<b>AMENDMENT OF SOLICITATION / MODIFICATION OF CONTRACT</b>			1. Contract Number	Page of Pages 1   2
2. Amendment/Modification Number DCKT-2011-B-0156-001	3. Effective Date See 16C Below	4. Requisition/Purchase Request No.	5. Solicitation Caption Installation of Storm Water Management System

Responses to Bidders Questions:

ATTACHMENT B – CONCRETED BLOCK AND CURB DETAIL

## TYPICAL 20"X12" CONCRETE BLOCK DETAIL

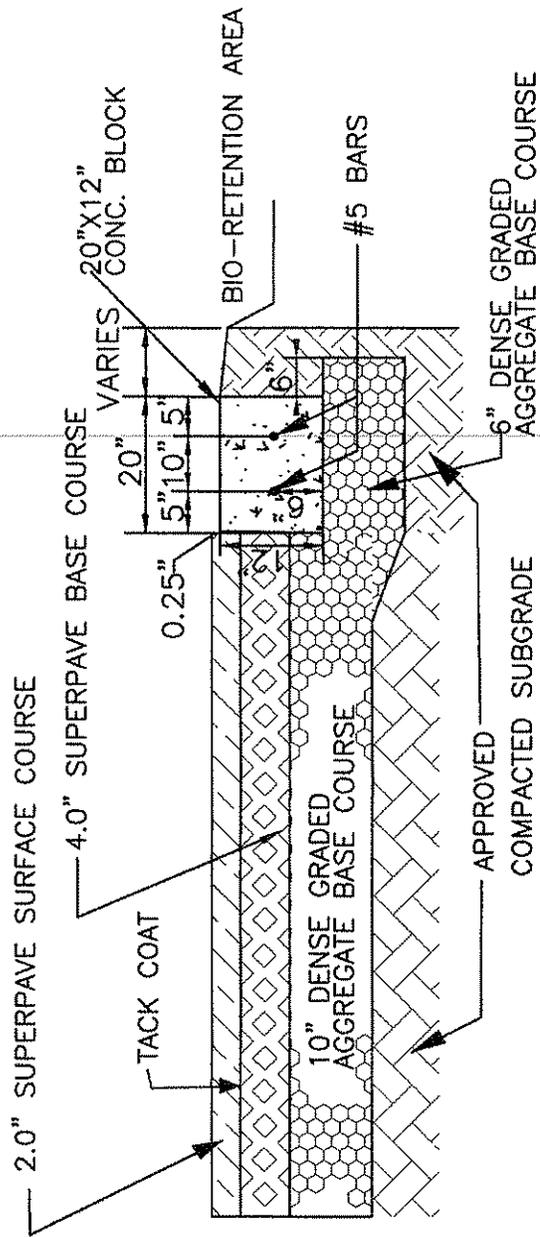
- A3. Yes there is .
- Q4. Certain locations of the site plan call for concrete block curb 20" wide by 12" height as per the Site Improvement Legend Item #3. Can you provide a detail of what exactly we are to install in the noted locations?

- A4. See attached concrete block and curb details. (Attachment B)
- Q5. Is the demo of the existing guard booth to include demolition of the existing slab or is the existing slab to be used for placement of the new 8' x 14' guard house?

**FRONT ELEVATION**

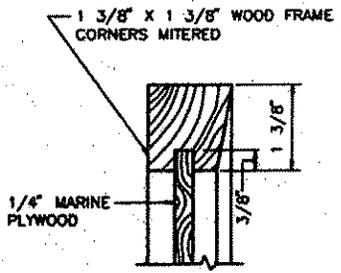
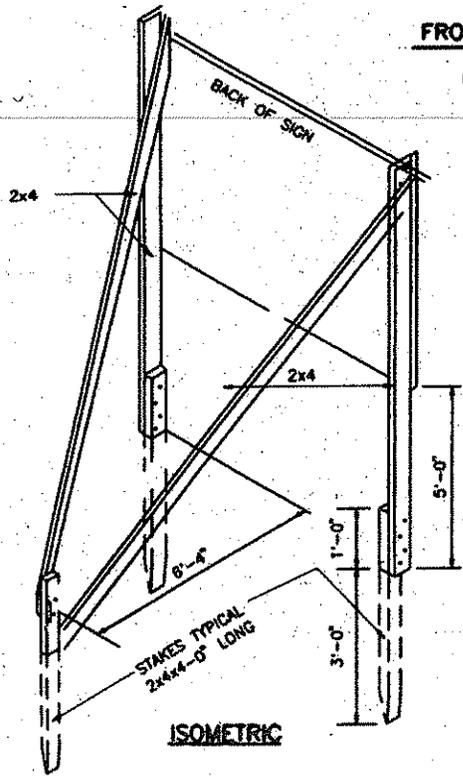
- Q9. Section C.2.7 of the bid documents specifies that a minimum of 2 construction signs with listed project information, contact information, etc. be provided by the contractor and installed on the site. Can you provide a detail for the sign requirements?

- A9. Please see attached details "Construction Sign Specs" (Attachment D). Replace the scripts on the signs reading "Office of Property Management" with "Department of Public Works" and "Anthony A. Williams" with "Vincent C. Gray".
